Rangitāiki River Scheme Review – April 2017 Flood Event

Final Report

18 September 2017

Prepared by the Rangitāiki River Scheme Review Panel

Figure 9: Sketch of the College Road floodwall breach (Source: Regional Council Contractor, 2017)

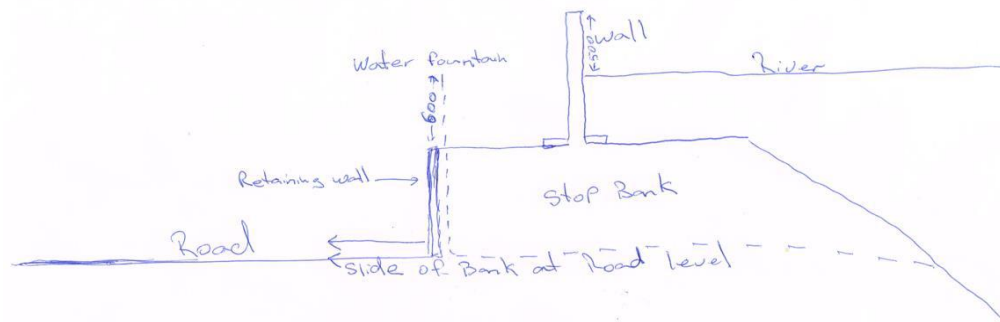
As I stood there a fountain of water came out of the ground just on the inside of the retaining wall [cribwall], next to the road. Then it proceeded in approximately 100mm increments north like a fan for about 15 meters [sic]. The water was about 500mm to 1 meter [sic] high in the air. I knew straight away the outcome of this wasn't going to be good so screamed at my truck driver to get in the truck and get out of harms way. I then proceeded to yell to the people around us and in the houses to get to safety. I watched as the ground from road level up push out. Then the concrete wall opened like two gates, with the wall splitting in the middle and water flooding through. The wall edges broke off and were pushed towards the west. At no time did the walls topple over they stayed upright. I then rang the [Works Coordinator] and informed him that it had breached. This was around 8.30am.”

Subsequent to giving this written statement the observer indicated that he could not be certain where the fountains sprang from, whether from the upper surface above the cribwall or from road level in front of the cribwall.

The Regional Council Contractor initially observed “the ground heaving and turning spongy” in a grassed area above the cribwall immediately next to the southern end of the concrete walkway and handrail (at the far end of the handrail, as seen in Figure 18). The handrail was then removed by the fire brigade and the Regional Council Contractor prepared to load the toe of the floodwall with “rotten rock”. As he stood and watched “a fountain of water came out of the ground just on the inside of the concrete retaining wall, next to the road”. This is shown on the sketch by the observer in Figure 9.

Figure 13: Cross Section of the 1993 College Road Floodwall (Source: Bay of Plenty Regional Council, 1993)

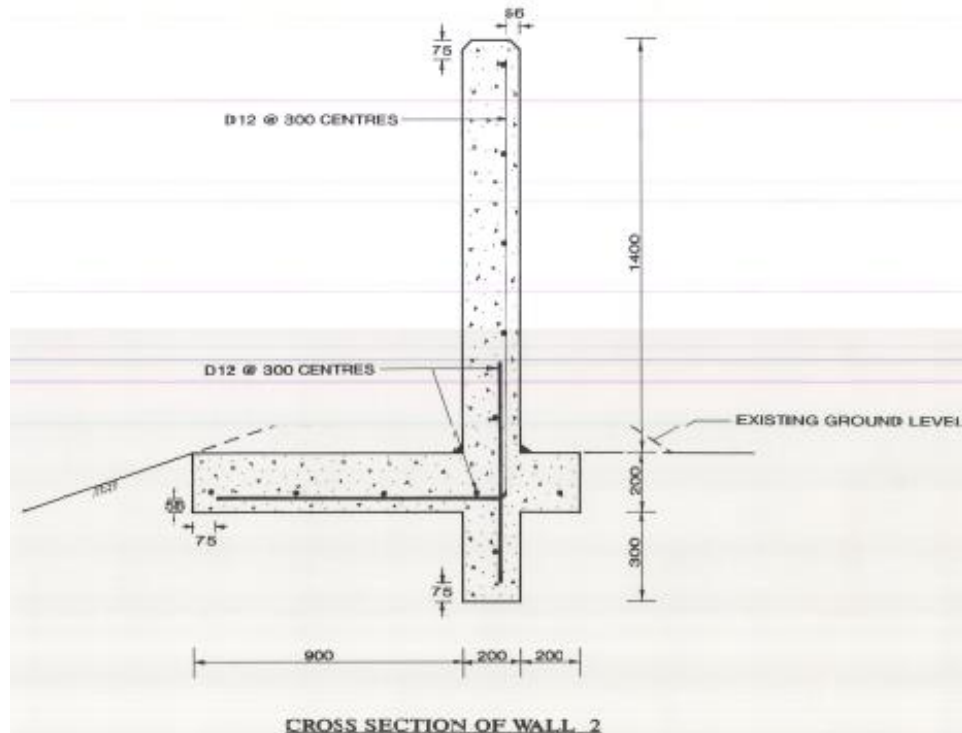
Two options were considered for the upstream wall between 54 and 64 College Road (the “College Road” floodwall). The option implemented was to remove the existing 2ft (610mm) high wall entirely and to construct a 98m long, 1.4m high wall in its place with a design crest level of 6.85m_{RL} (Figure 13). The contract

The contract documents for the remediation work on the walls included earthworks. However, all of these earthworks were associated with the alternative option, which was not implemented. There was no requirement for any constructive earthworks for the option implemented. Instead the construction drawings required that the existing stopbank be *lowered*: “existing stopbank lowered to R.L. equal to top of footing RL”, Drawing 93-02 R674, sheet 2 of 4 dated August 1993 (Bay of Plenty Regional Council, 1993), Figure 14. The drawings also required the wall to be constructed “on the same location as the old wall”.

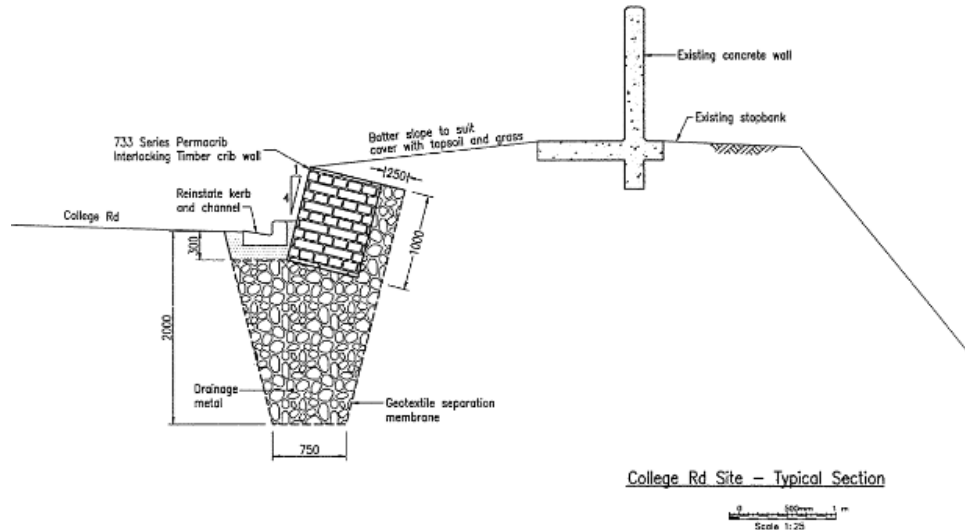
The **toe drain** consists of a 2m deep trench lined with **geofabric** and filled with "**drainage metal**". The cribwall sits on top of the riverside side of this trench, as shown in Figure 15, and the recent investigations have shown that it is filled with a very coarse and open angular gravel/cobble sized free-draining fill. It is usual to use geotextile in these situations, and is explicitly recommended for cribwalls in a similar situation in Section 3.5.4 of the *Regional Council Stopbank Design and Construction Guidelines* (Britton Consultants, 2014)

Figure 16: Section through proposed mowing strip and handrail, as proposed on the Application for Bylaw Authority (Source: Bay of Plenty Regional Council, 2012)

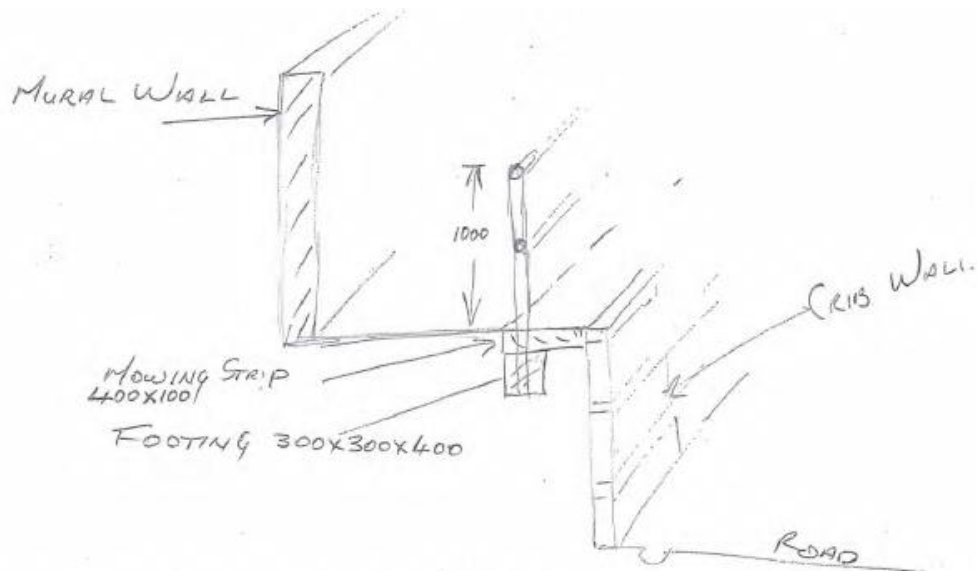
A handrail and concrete walkway (“mowing strip”) were constructed over a 20m long section of the cribwall in 2012 as part of the 2km long Rangitāiki River Walkway. These are shown on the photograph Figure 18. The concrete surface was cast to create a wide footpath and wheel chair access past the floodwall, and was approved by the Regional Council under the Authority of the Floodway and Drainage Bylaw, 2002, through an application made by the Edgecumbe Community Board. The Regional Council have indicated that this application was approved by a Regional Council staff member with some 25 years of varied experience on flood protection work, including working closely with their geotechnical specialist.

The concrete slab, about 75mm to 100mm thick, covered the ground surface between the top of the cribwall and the edge of the slab connected to the floodwall. The handrail was installed into footings shown on the Bylaw Application as 300 x 300 x 400mm concrete footings sunk into the top of the cribwall. Details of the arrangement, as submitted on the Application for Bylaw Authority, are shown on Figure 16. This sketch shows the mowing strip at its narrowest and its full extent can be better gauged from the photograph in Figure 18.

Placement of the concrete footings for the steel handrail has been investigated and discussed with the operators who carried out the installation in 2012. The concern of the Review Panel was whether the concrete was fluid enough to flow down into the cribwall fill, and whether a significant quantity was lost in this way. It was established that the footing holes were not lined, but the operators were clear that concrete was not lost into the ground beneath the footings.

Figure 19: Seepage immediately in front of the floodwall at 07:04 on 6 April, an hour and a half before the breach (Source: an Edgcumbe resident, 2017)

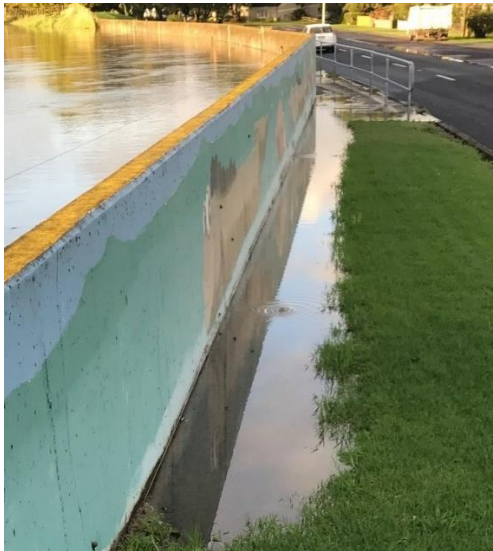
Observations by others, supported by one photograph taken at 07:04 (Figure 19), have confirmed that seepage was seen rising out of the surface immediately next to the wall during the last couple of hours before the breach, and that this seepage occurred “the whole way along the wall”, “between the handrail and the wall”, and “around the steel handrail”. The obvious seepage showing in the photograph in Figure 19 appears to emanate from a construction joint in the concrete slab, as does a second seepage point further along the wall. This seepage may come directly from the river side by passing through the joint in the key below ground level, but alternatively it may simply reflect pore pressure escaping from below the slab. Observations were also made by the same observer that some water was flowing up between the tarmac seal and the concrete kerb at the road edge.

Gaps at construction joints between the keys would have allowed seepage to pass directly from the riverside to the landward side below slab level without being forced down to the bottom of the key and significantly shortening the intended flow path. This would have had the effect of increasing pore pressure below the base slabs on the landward side of the wall. Seepage which may be attributed to this can be seen in Figure 19, but the source of the seepage seen in the photograph is not obvious.

Figure 22: Particle Size Distribution of “rotten rock” recovered from the wall foundation (Source: Beca, 2017)

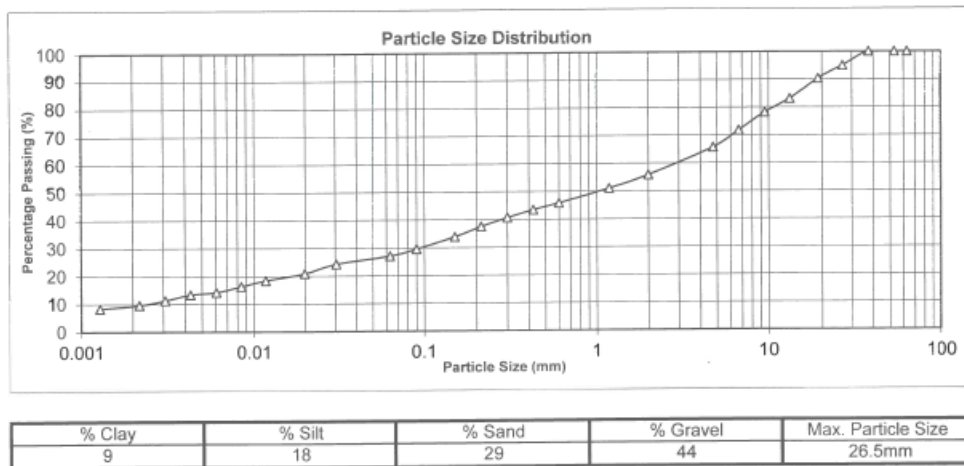
Particle size distributions obtained from samples of the “rotten rock” recovered from the wall foundation indicate that around 25% of those samples of the material is of silt or clay size particles, with just under 10% by weight being clay size particles (finer than 0.002mm), as shown in Figure 22. A homogeneous material with this proportion of fine particles can be expected to have a low permeability, of a similar order to or lower than that of the silt alluvium, and much lower than the typical locally found fine sands which are commonly used in stopbanks. If properly placed and compacted, this material would be expected to provide a good foundation for a floodwall, and even act as a **cutoff** below the wall if it penetrates sand layers. Where it has been placed under water, which may have happened to rebuild the river bank, but probably not the wall foundation, the material will most likely have segregated and formed zones of high permeability. Since the river bank appears to have been rebuilt both after the earthquake and again in 2004 it is quite possible that open channels existed within this zone, providing a foreshortened seepage path to the wall foundation soil.

Figure 24: Matahina Dam Operation 3 – 9 April 2017 (Source: Trustpower, 2017)

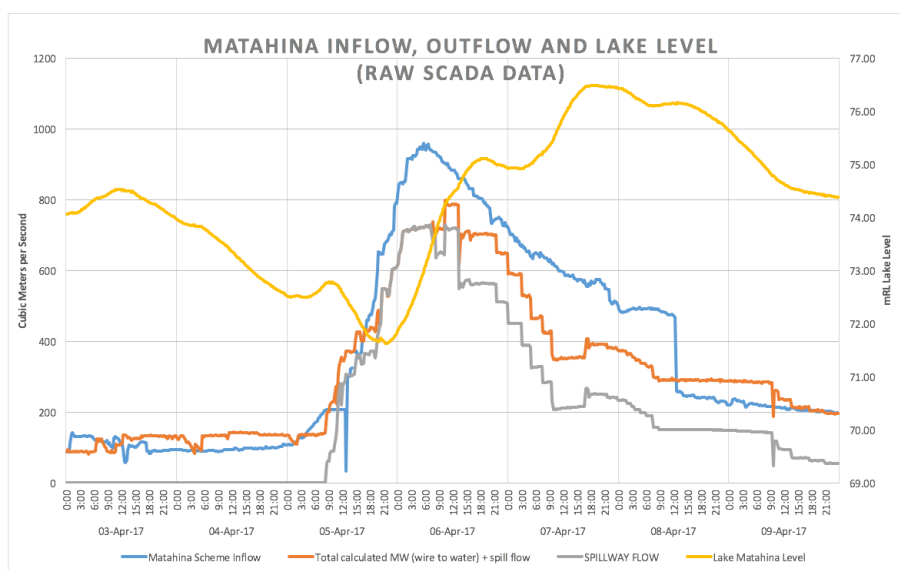
Table 5 below provides a timeline of the key events and actions that occurred during the April 2017 event. The effects that these actions had on the Lake Matahina water level and dam outflows is shown in graphical form in Figure 24 which was provided by Trustpower to the Review Panel. Trustpower have informed the Panel that the Matahina Scheme inflow (peak 960m³/s) presented in Figure 24 was derived from approximate calculations undertaken on measured upstream flows. More detailed post event analysis undertaken by Trustpower suggested that the actual peak instantaneous flow was most likely in the region of 920 to 930m³/s.

There is also a 50mm difference in the minimum Lake Matahina level presented in Figure 24 (71.62mRL) compared with the minimum lake level (71.57mRL) presented in Table 5. Trustpower have explained that they have three water level measuring instruments over the operational range of the lake. The lower level presented in Table 5 was the instantaneous level displayed at Trustpower's Operations Centre during the event, whereas the higher level presented in Figure 24 was from one of the other level measuring instruments. This difference is explained by the different instrument types, calibration intervals, signal frequency and wave action. This explanation is accepted by the Panel and the presentation of the levels available at Trustpower's Operations Centre during the event is considered reasonable.

Figure 29: Comparison of Lower Floodway Widening Options (Source: Opus International Consultants, 2007)

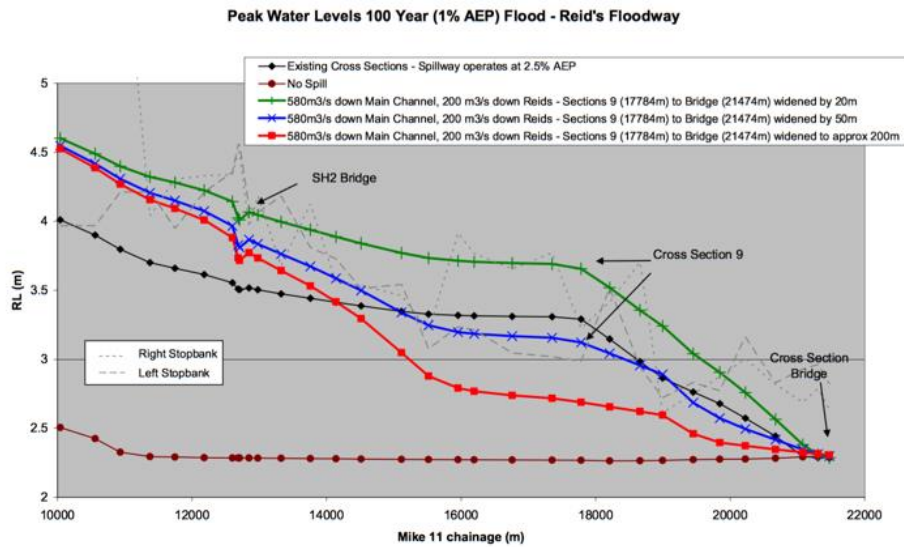
Also included in the analysis was an option of only widening the floodway by 20m, which did not provide enough benefit, as well as widening it to 200m, being approximately the same width as the section upstream of McLean Rd to the confluence of the main river. It was reported by Opus (2007) that widening the lower reach out to 200m reduced maximum water levels significantly, “particularly from the SH2 Bridge to upstream of the confluence with the main river channel”, with a flood level reduction of 0.88m. Inspection of the model outputs shows that the option to widen the lower floodway to 200m also reduced flood levels by approximately 0.5m from McLean Road to Cross Section 9 when compared with the option to widen the lower floodway by 50m (See Figure 29).

It is interesting to note, given the benefits highlighted above, that the decision was made to recommend widening the channel by only 50m rather than out to 200m. This appeared to be driven by the conclusion that the 50m widening provided adequate benefit and the design flow of 200m³/s could be “accommodated within the floodway at current design levels” (Appendix 12 – Summary of Scheme Design Parameters Opus, 2009). It was highlighted that this “accommodation” was only marginally achieved as there was still minor stopbank “top-ups” required which would be provided for through longer term asset renewals in the Regional Council Asset Management Plans. On this basis, the 50m widening was concluded by Opus “to be optimal” (Opus International Consultants, 2007).

Figure 31: January 2017 assessment of works to complete Reid's Floodway upgrade (Source: Bay of Plenty Regional Council Presentation to RRSR Panel, 8 June 2017)

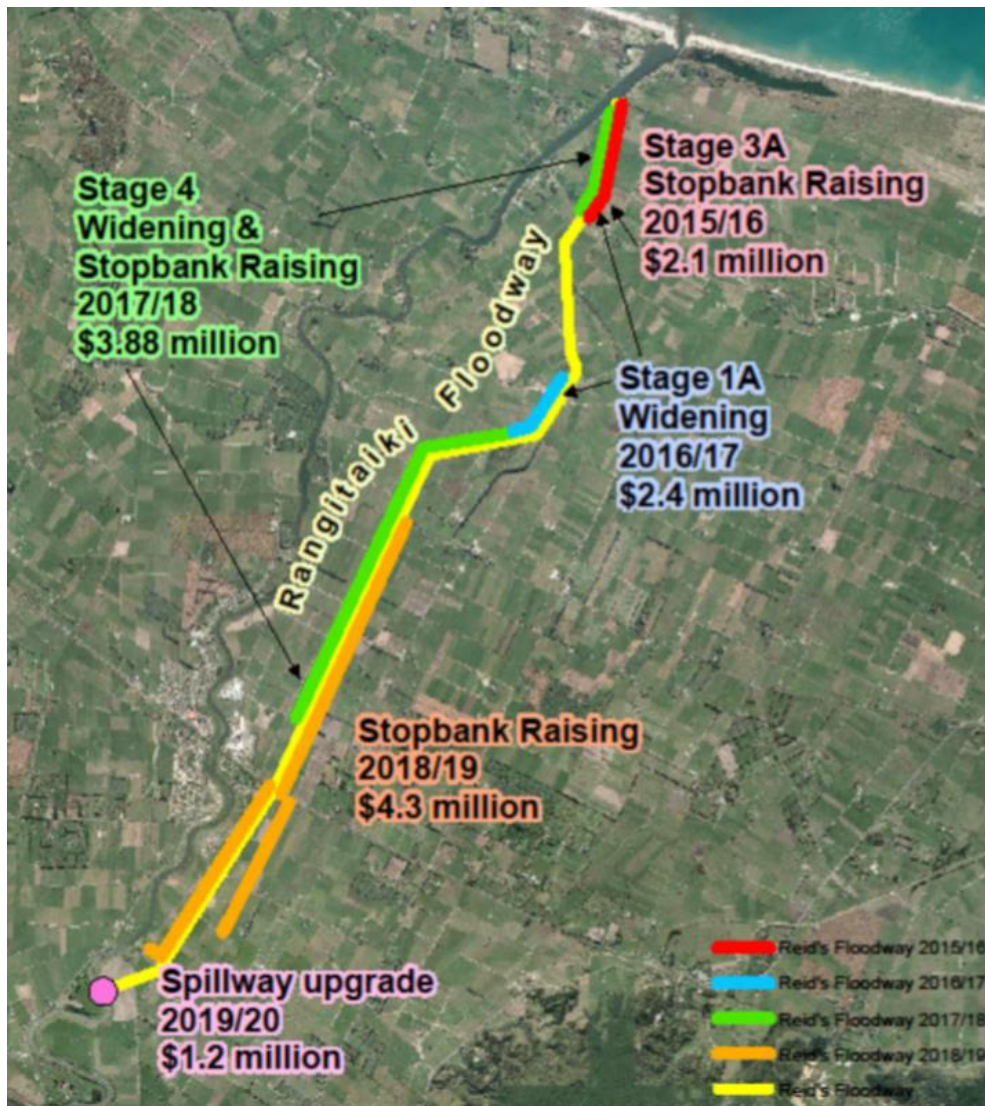
The most recent (January 2017) assessment of the works to complete the Reid's Floodway upgrade is shown in Figure 31 below (Bay of Plenty Regional Council, 2017c). The Regional Council has also been undertaking preliminary scoping investigations on a number of options to reduce the extent of stopbank raising in the upper floodway. These options include a secondary outlet to the main Rangitāiki River upstream of Thornton Hall Road Bridge combined with controlled spilling upstream and downstream of SH2 as well as downstream of Thornton Road. The Panel acknowledges that further analysis and consideration of the feasibility of these options is required before the final plan for the works to complete the Reid's Floodway upgrade can be determined. This is discussed further in the Long Term Strategy section of this report.

It is highlighted that the works that are currently being investigated by the Regional Council are in-effect providing the same reduction in flood levels that could have been achieved if the lower floodway had been widened by 200m.

- z. The stopbank raising for both banks of the upper reach of Reid’s Floodway allowed for in the current (2015-25) long term plan would appear to be a poor option given the well-known geotechnical complexities of the underlying geology. It is also considered that stopbank raising is not aligned with the visions and objectives of the Rangitāiki River Document or generally accepted best practice.
